Contract #: 04-0120F4
 Cty: SF/ALA Rte: 80 PM: 13.2/13.9
 File #: 69.25B

QUALITY ASSURANCE -- NON-CONFORMANCE REPORT

Report No: NCR-000410

Reference Description: Missed MT indications on East Tower, Lift 2 cowling plate weld

项目名称 Project Name:	美国海湾大桥 SFOBB	部件图号 Drawing No.:	ESD1-SA300B/F	报告编号 Report No.:	T-CWR315
合同号 Contract No.:	04-0120F4	部件名称 Item Name:	2 nd lifting Tower(E)	NDT 报告编号 NDT Report No.:	T787-MT-6174
项目编号 Project No.:	ZP06-787

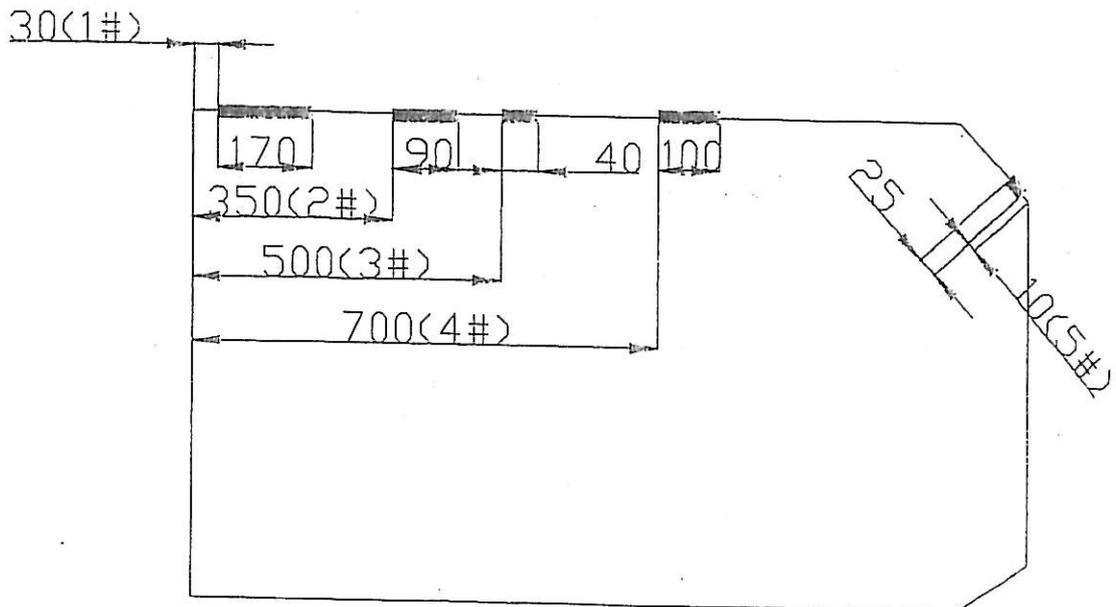
在对ESD1-SA300B/F-6检测时, 发现5处纵向裂纹。L1=170mm L2=90mm L3=40mm L4=100mm L5=25mm

Five longitudinal cracks were found by use of MT on ESD1-SA300B/F-6.

1. Moisture wasn't completely removed during drying operation (preheating) or the area wasn't preheated sufficiently

1. QC shall monitor and direct the welder and the grinder doing the repair operation.
2. Preheat before gouging; the temperature shall be at least 65°C.
3. Gouge the weld to remove identified defects.
4. Joint details shall refer to the approved WPS repair.
5. Grind the gouged areas to a smooth and shiny surface.
6. Verify with VT and MT to ensure no defects remain in the weld joint prior to welding.
7. QC shall monitor all welding passes being deposited.
8. QC shall ensure all slag has been removed prior the deposition of next pass.
9. Preheat and maintain interpass temperature control in accordance with the WPS.
10. Blend the weld repaired areas into the adjacent weld or base metal by grinding.
11. Perform VT, MT and UT NDT inspection to the repaired areas.

1. QC shall verify sufficient preheat has been applied, to remove moisture, prior to welding.
